HISTORIC AND DESIGN REVIEW COMMISSION

April 06, 2016

HDRC CASE NO: 2016-106
ADDRESS: 902 N HACKBERRY ST
LEGAL DESCRIPTION: NCB 530 BLK 14 LOT S IRR 56.1 FT OF A-4
ZONING: R5 H
CITY COUNCIL DIST.: 2
DISTRICT: Dignowity Hill Historic District
APPLICANT: Maria Gonzalez Salazar
OWNER: Maria Gonzalez Salazar
TYPE OF WORK: Door replacement and railing
REQUEST:

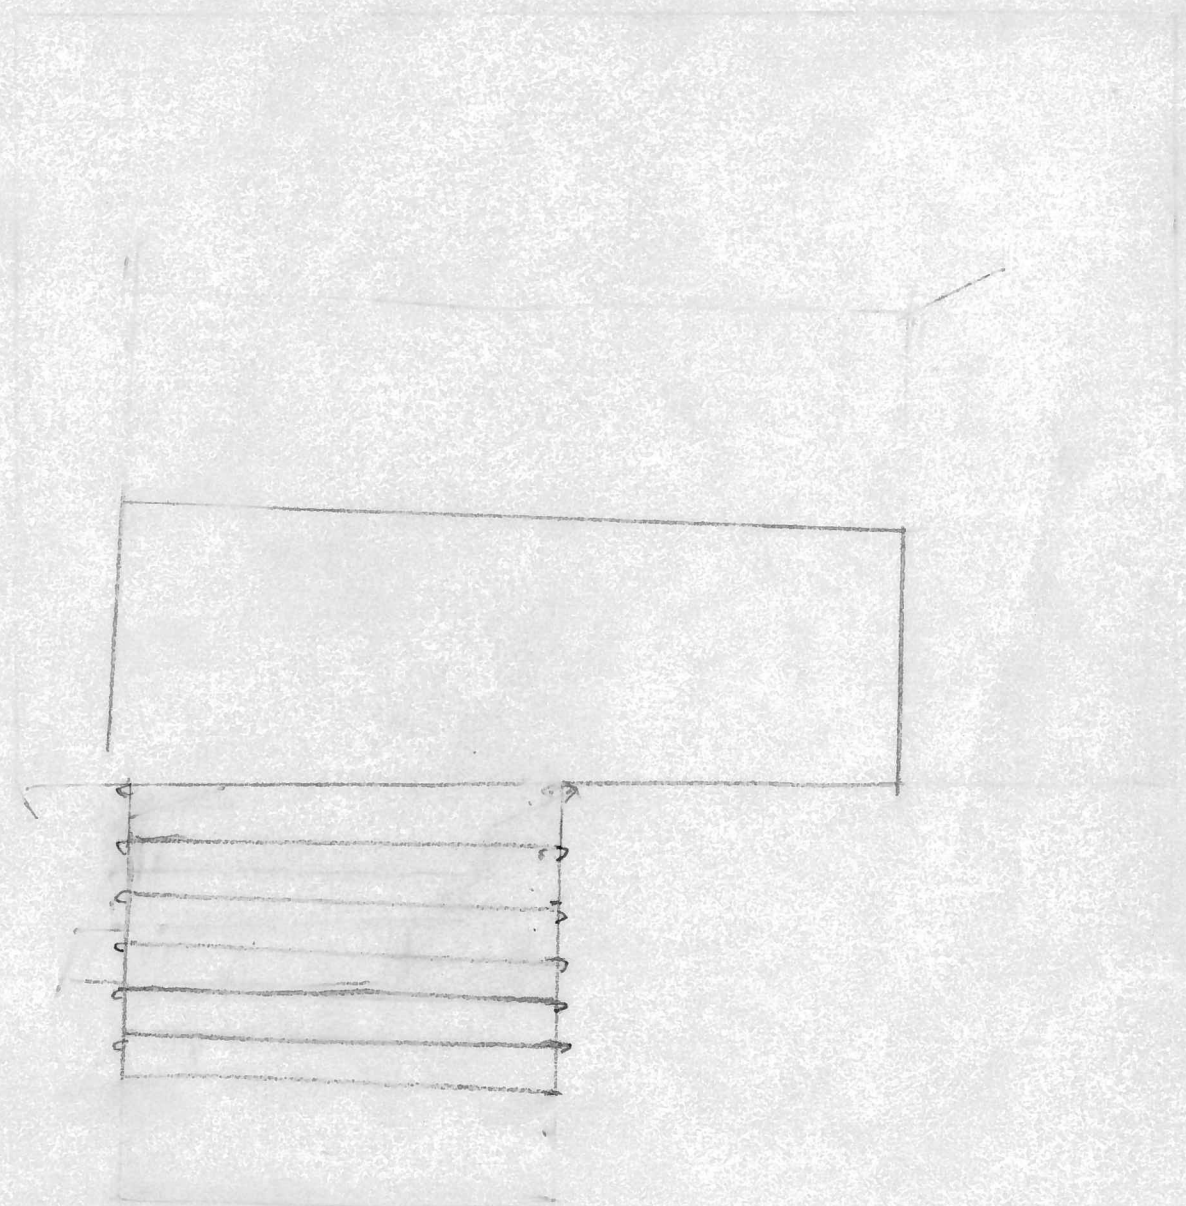
- c. The existing concrete porch steps currently do not feature a railings, however, the front porch features a modest low height railing. The applicant has proposed to install stair railings on each side of the front porch steps to be wooden and three feet in height. The applicant has noted that these proposed railings will be painted white to match those that are existing.

- d. Staff finds the proposed railings are simple in design as to neither present a false sense of history nor diminish the architectural integrity of the existing front porch. Staff finds the applicant's proposal appropriate.

Staff recommends approval of item #2 based on findings c and d.
